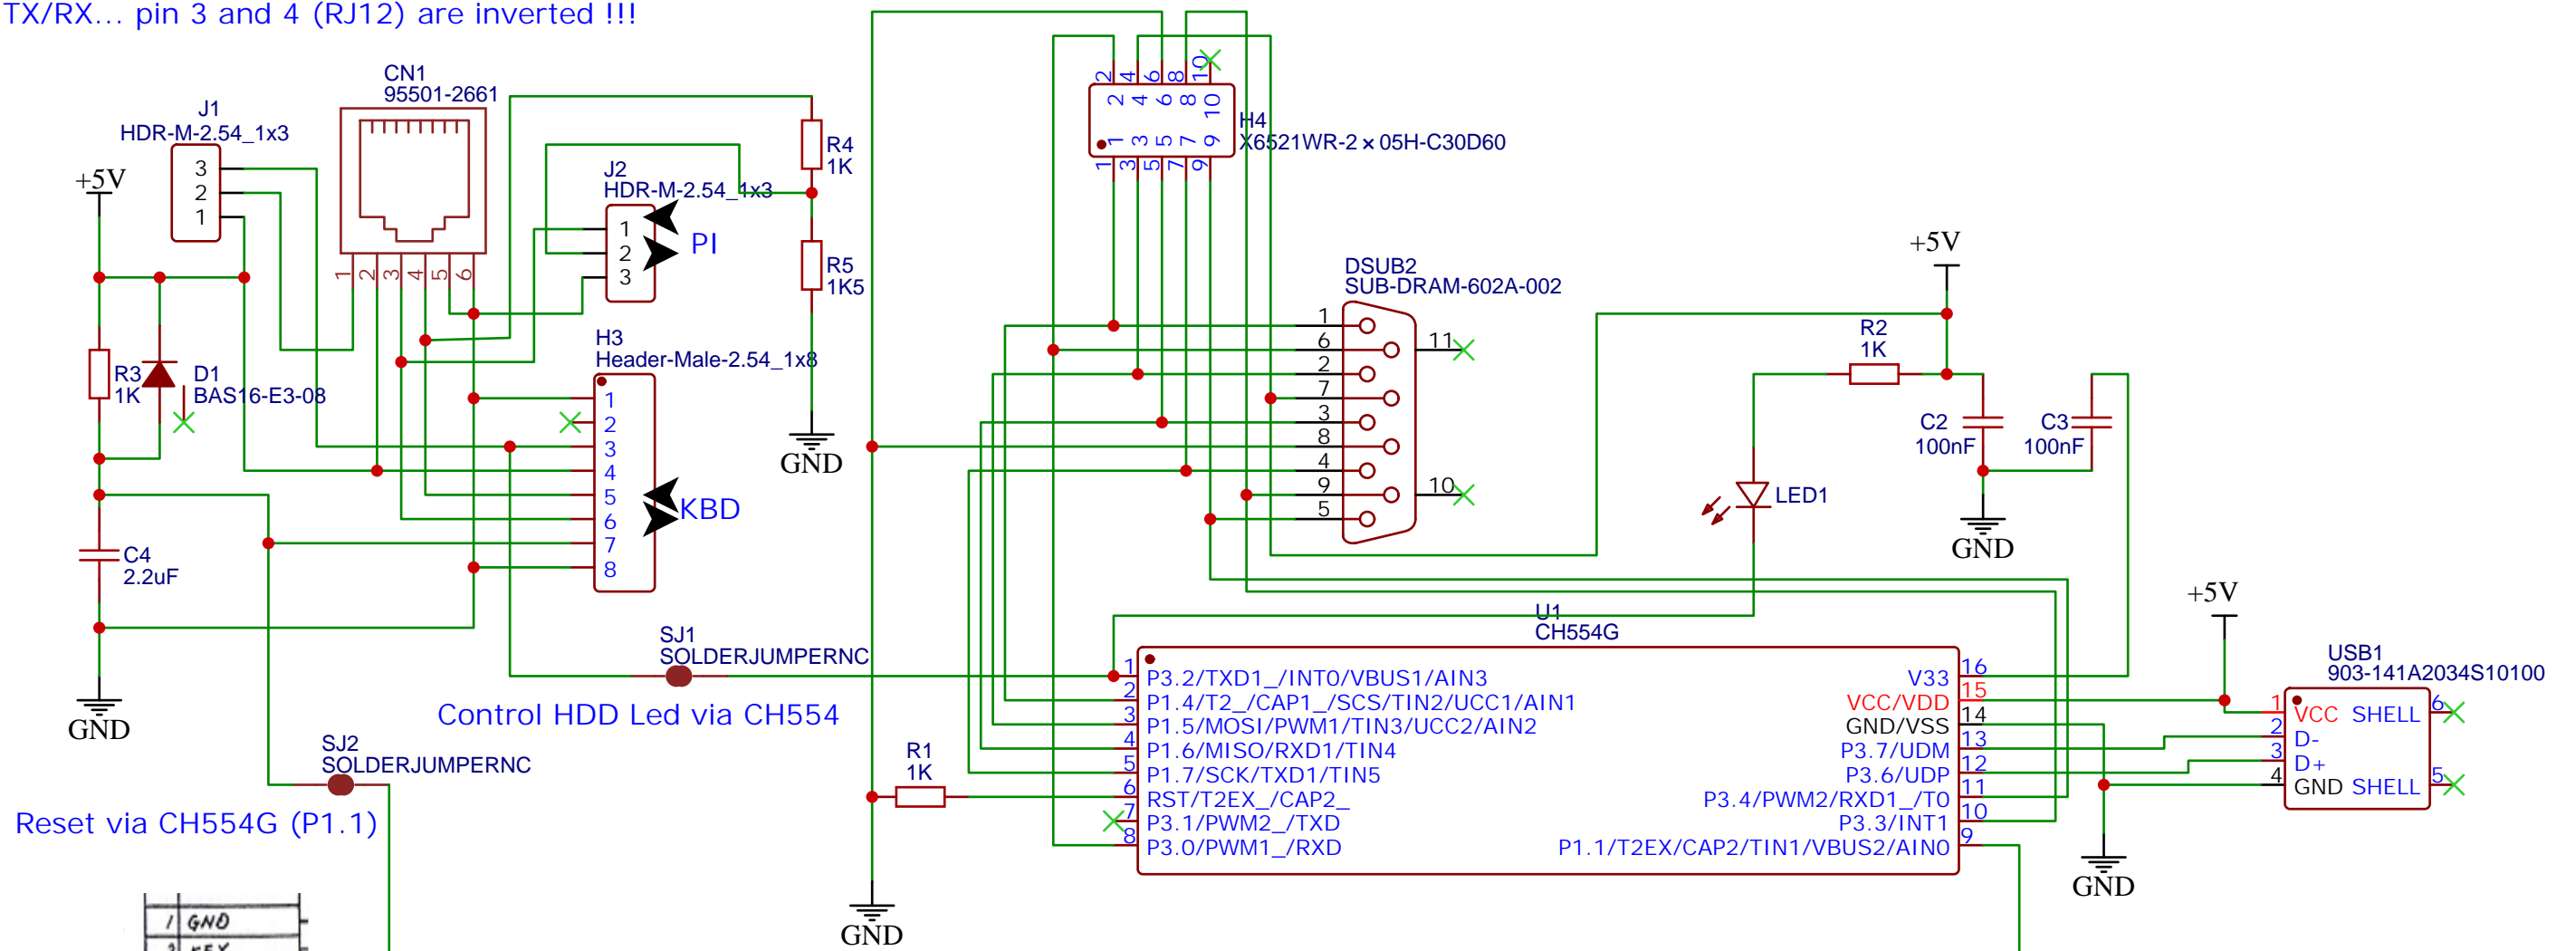
On produced PCBs (fev 2022),  
pin 1 and 2 (RJ12) should be inverted !!!  
TX/RX... pin 3 and 4 (RJ12) are inverted !!!
